RE: Rogers Pollution Control Fac. Inspection

AFIN: 04-00155 Permit No.: AR0043397

OFFICE OF WATER QUALITY INSPECTION						
ADEQ		REPORT						
A R K A N S A S Department of Environmental Quality		AFIN: 04-00155 PERMIT #: AR0043397				DATE: 4/3/2019		
		COUNTY: 04 Bento	n	PDS #: 10772			MEDIA: WN

RE: Adequate Response to Collection System Inspection

- 1. Screen shot of Camden Way SCADA screen.
- 2. Screen shot of Dixieland Crossing SCADA screen.

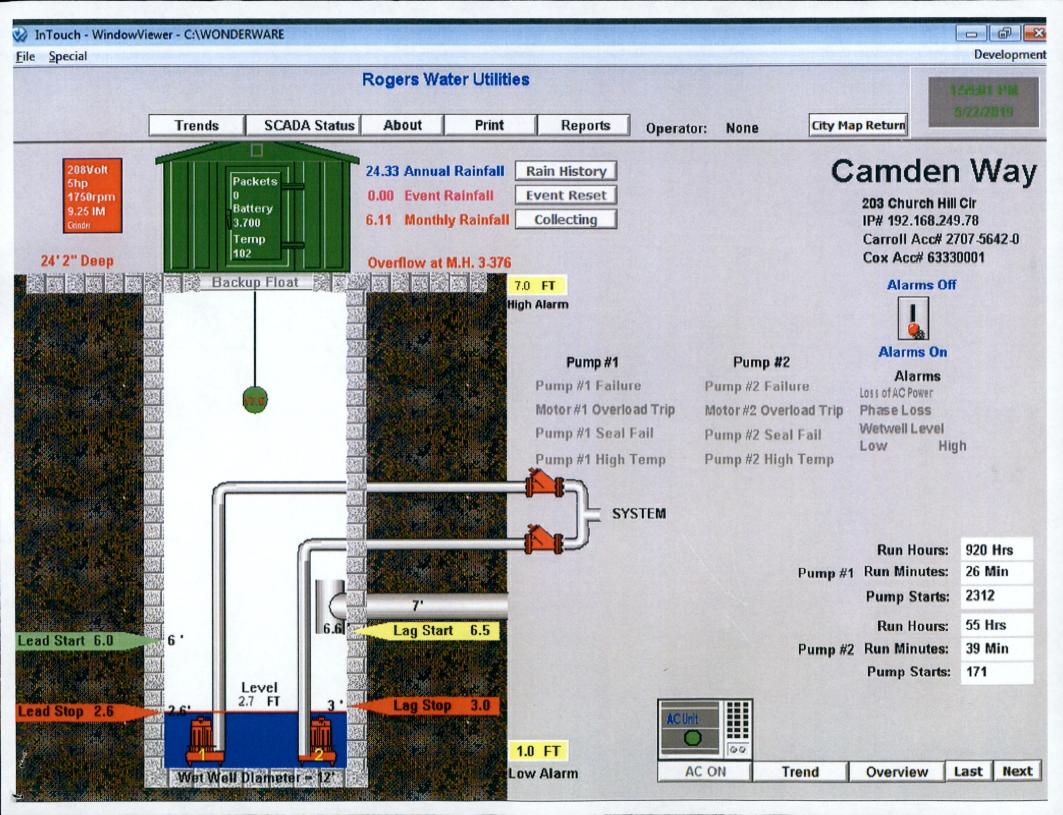
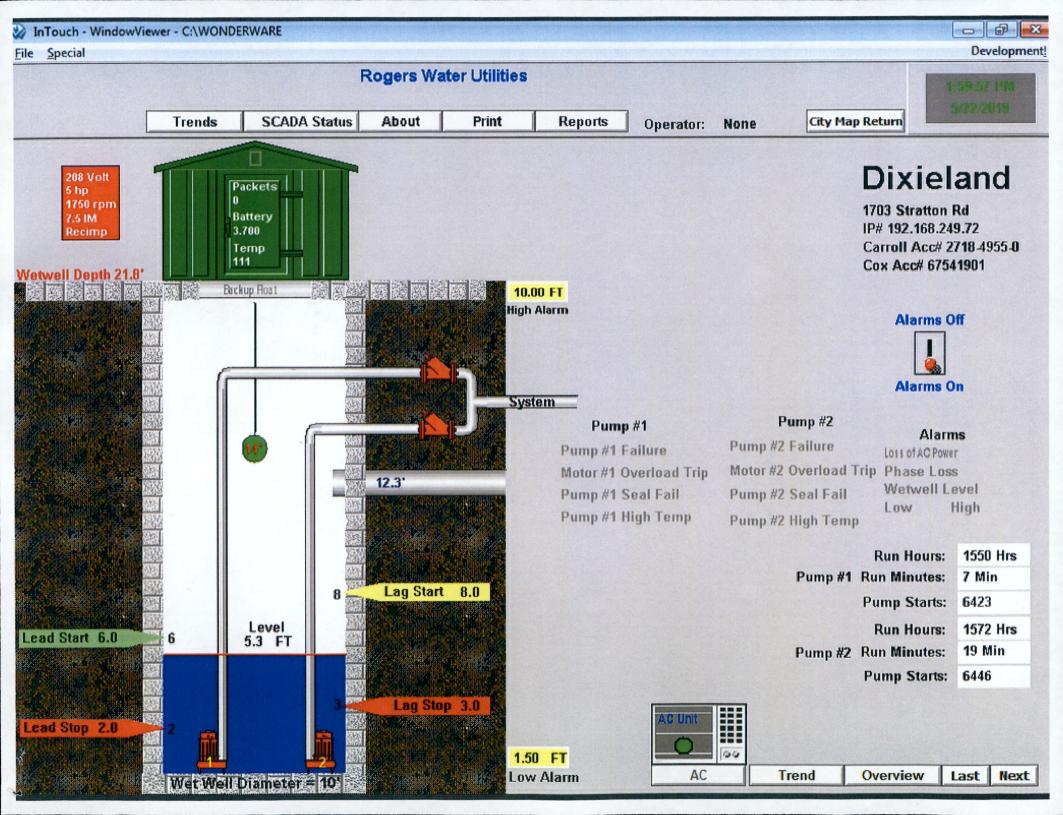
Please accept this letter as the required response to your findings detailed in your May 9, 2019 letter. These findings were 1. Emergency contact information was not posted at the lift stations. These are violations of Part III, Section B.1. of the permit.

All of our lift stations are continuously monitored around the clock. The Rogers Water Utilities SCADA system monitors the following on all lift stations: pump failures, motor overloads, pump seal fails, loss of A/C power, phase loss, wetwell levels, backup battery levels, information packets exchanged, and temperatures within the instrumentation panel. If any of these values exceed parameters, an alarm is initiated and sent via WIN-911 software to a designated on-call field technician with a smart phone, as well as their manager. If the issue cannot be handled via the SCADA system, or if the SCADA system is unable to communicate with the site, a field technician is dispatched to get a visual on the lift station.

We will always be made aware of any issues with any of our lift stations well before the general public would be able to see anything wrong with our facility. Of course, if there were some other kind of issue that occurred on our lift station property, we believe it would be due to a circumstance that would warrant a 911 call, not a call to RWU.
